Cool Boss Technical Service Bulletin

Installation and Operation Manual Update

BendPak TSB 120-052023

5900274, Rev. A3, page 6 & page 8.

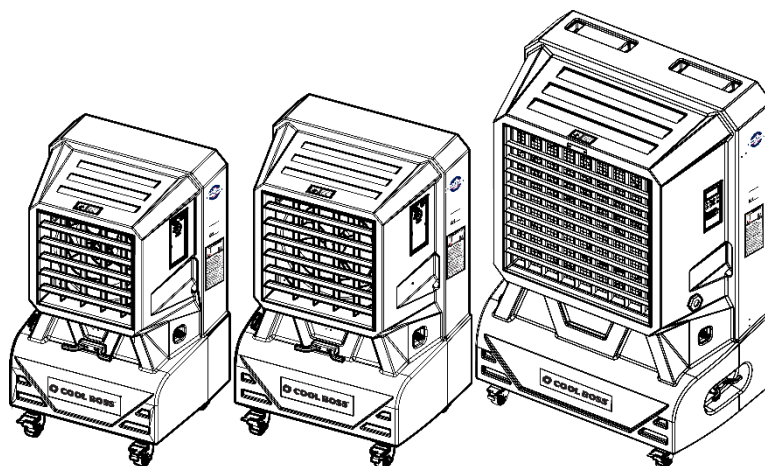
– **Replace** the following Max. Airflow (CFM) and Cooling Area (sq. ft.) data.

COOLBREEZE Swing Louver Models (Cool Boss Spec. Change)						
Model No.	CB-12 (existing specs)	CB-12 Revised Spec	CB-14 (existing specs)	CB-14 Revised Spec	CB-26 (existing specs)	CB-26 Revised Spec
Max. Airflow (CFM)	1,565	1,850	2,300	2,715	6,027	7,115
Cooling Area (sq. ft.)	650	770	850	1,005	2,585	3,055
